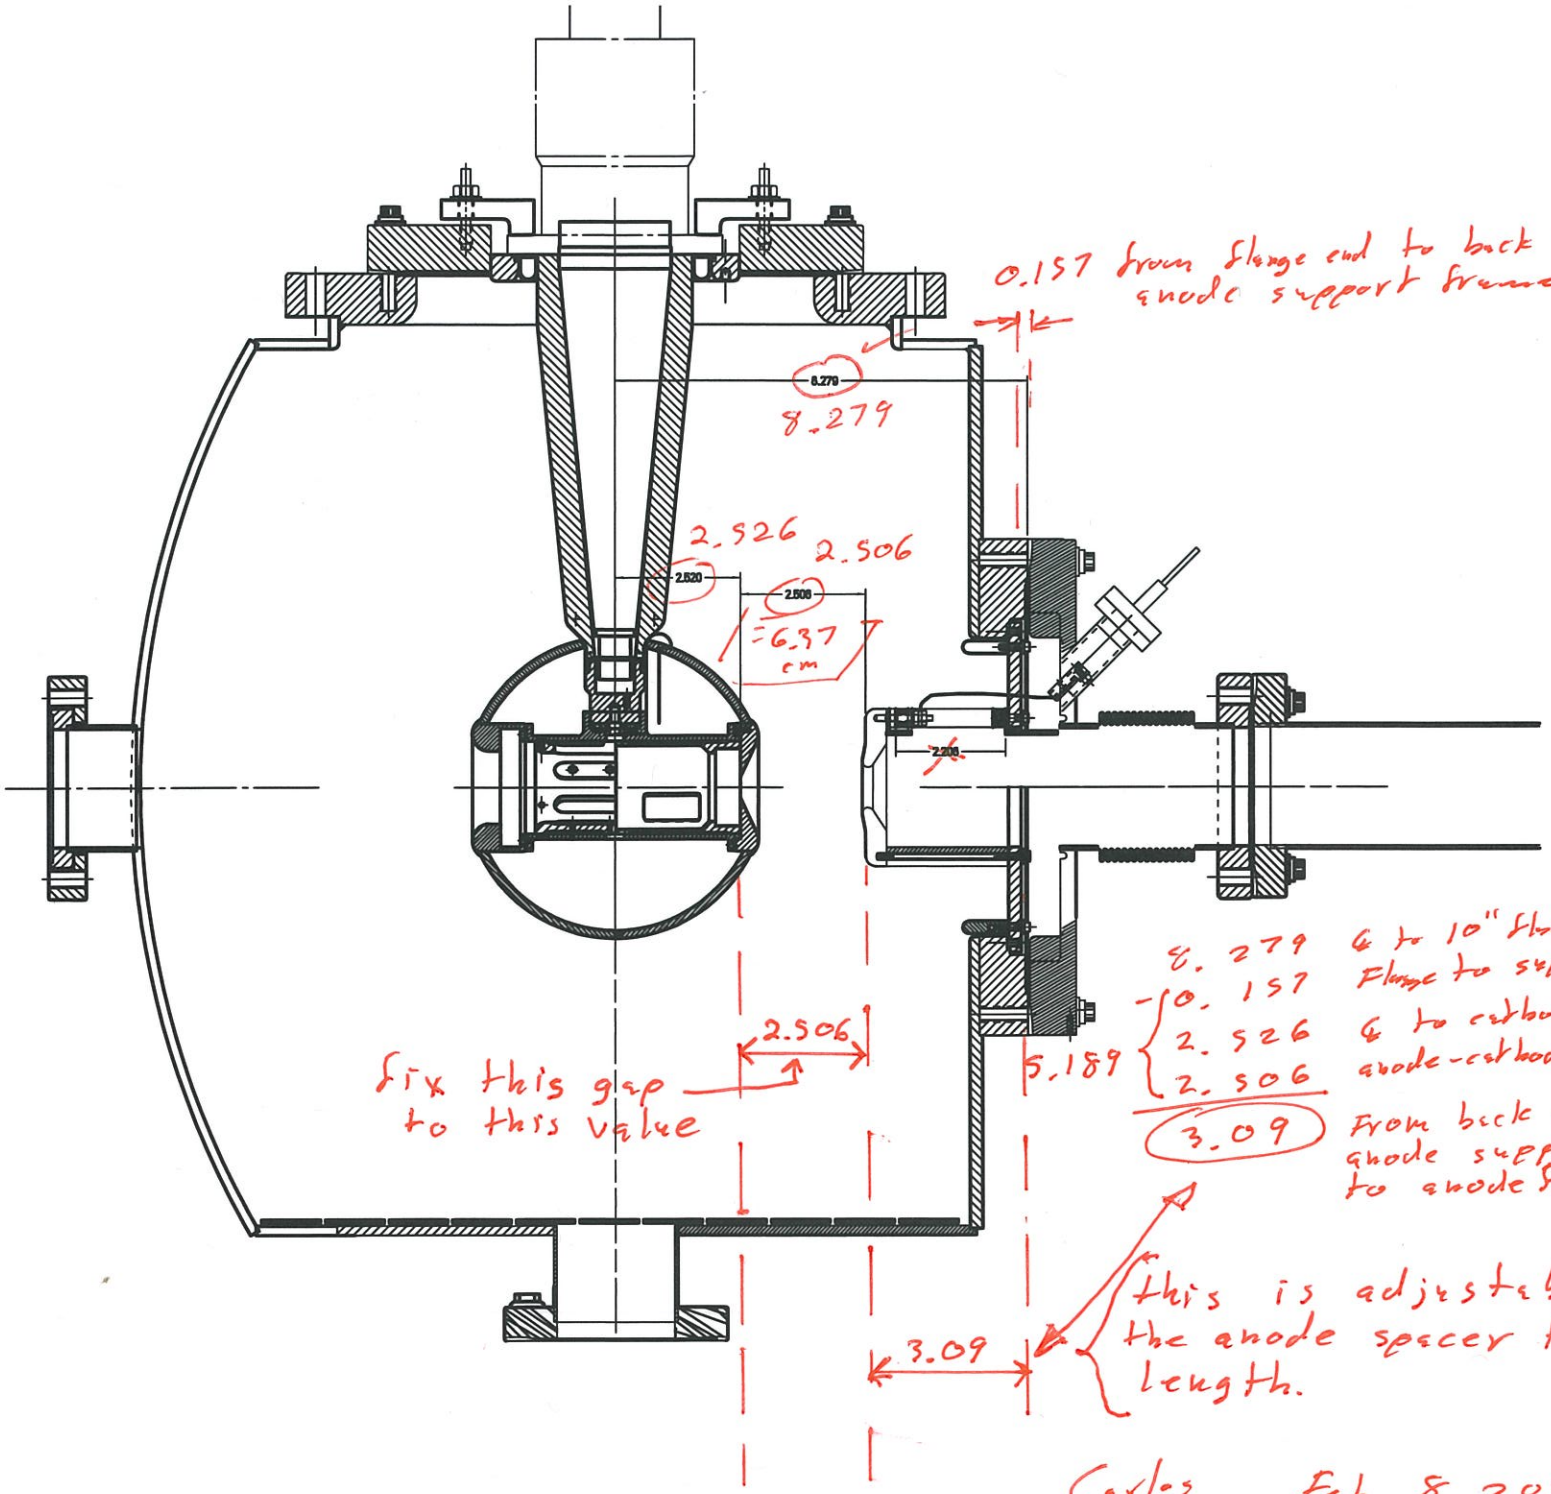
8.279	℄ to 10" flange
−0.157	Flange to support frame
2.526	℄ to cathode
2.506	anode-cathode gap
3.09	From back end of anode support frame to anode flat face.

this is adjustable with the anode spacer tube length.
